FACILITY POST-EXAMINATION COMMENTS

FOR THE KEWAUNEE INITIAL EXAMINATION - NOVEMBER 2005

**DOMINION ENERGY KEWAUNEE, INC.
KEWAUNEE POWER STATION
OPERATOR LICENSE EXAMINATION**

A review was conducted of the RO/SRO written examination administered Friday, November 18, 2005, at the Kewaunee Power Station. The review identified errors in two questions that were not identified prior to exam administration. The following is being requested:

DRAWING OPERXK-100-132, FLOW DIAGRAM
WASTE DISPOSAL SYSTEM

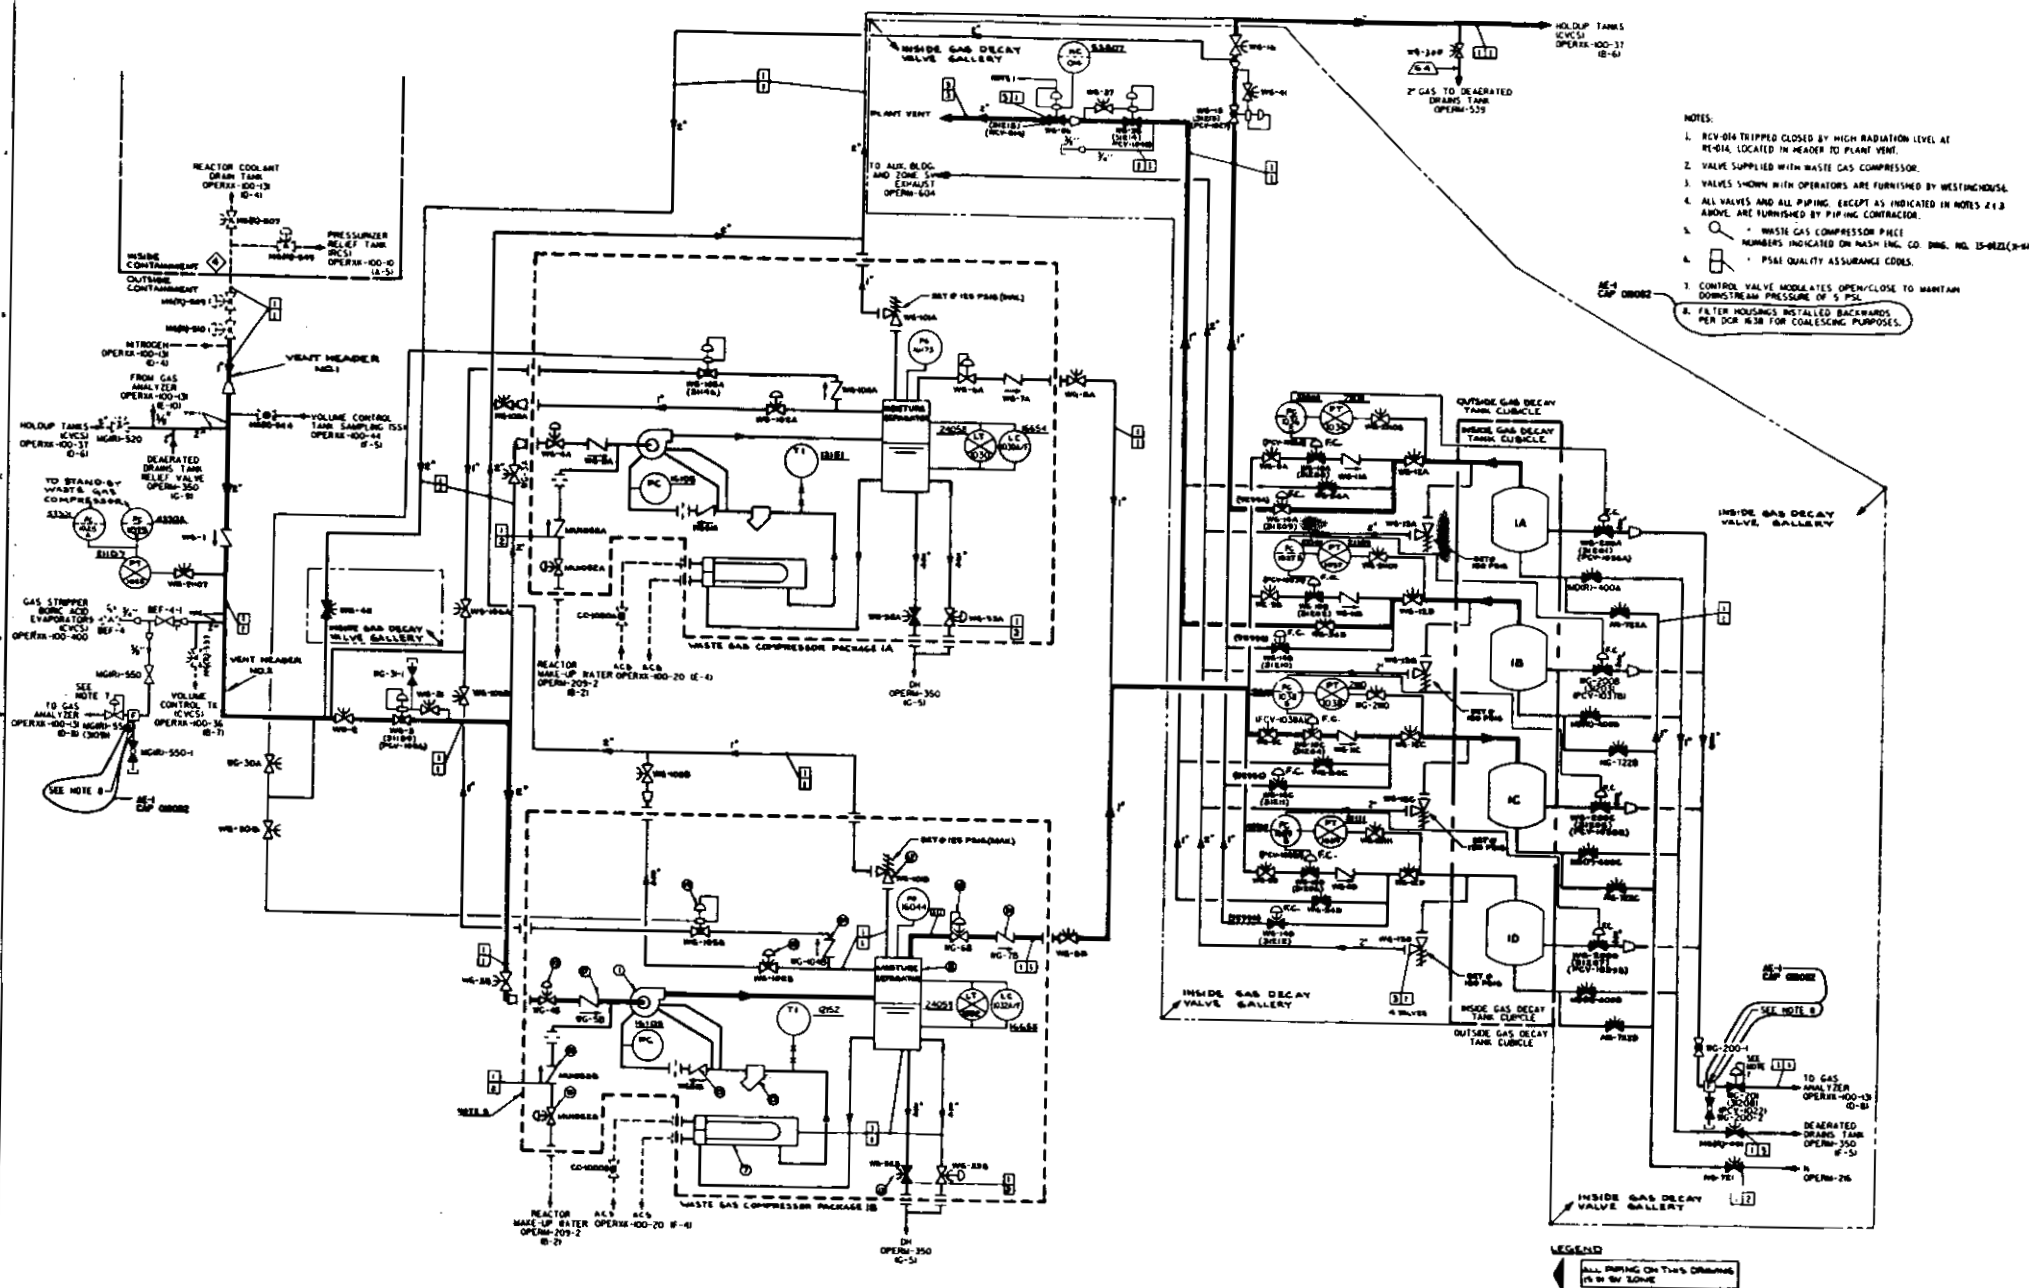
A pen and ink correction is required to properly identify the Waste Gas Decay Tank A relief valve. The actual valve nomenclature is WG-13A.

The premise identifies the Waste Gas Decay Tank A Relief Valve as WG-14A. The actual valve identifier is WG-13A. It is believed that this error does not invalidate the question but should be treated as a typographical error. WG-14A is not the relief valve but has the nomenclature, "WG-14A/CV-31209 Waste Gas Tank 1A to Holdup Tanks." During the examination no individual questioned the difference between the valve number and the description provided. If someone thought the valve in question was other than the Waste Gas Decay Tank Relief, this should have been questioned during this time.

In the stem of the question it lists WG-14A as the relief valve for WGD T A. It is not. The stem of the question is wrong. If WG-14A were to lift at full tank pressure it could rupture the vent header and R-4 could be a possible answer. Recommendations: Accept both answers "C" and "D" and revise question.

While the question does use the incorrect valve identifier number, WG-14 A versus WG-13A, it does identify the valve as the "relief valve for that tank." WG-14A is not the relief valve but has the nomenclature, "WG-14A/CV-31209 Waste Gas tank 1A to Holdup Tanks." During the examination no individual questioned the difference between the valve number and the description provided. If someone thought the valve in question was other than the Waste Gas Decay Tank Relief, this should have been questioned during this time. The valve number error is a typographical error and does not affect the quality of the question.

The Evaluation does not require change. A Question Change is required to correct the valve identifier number.
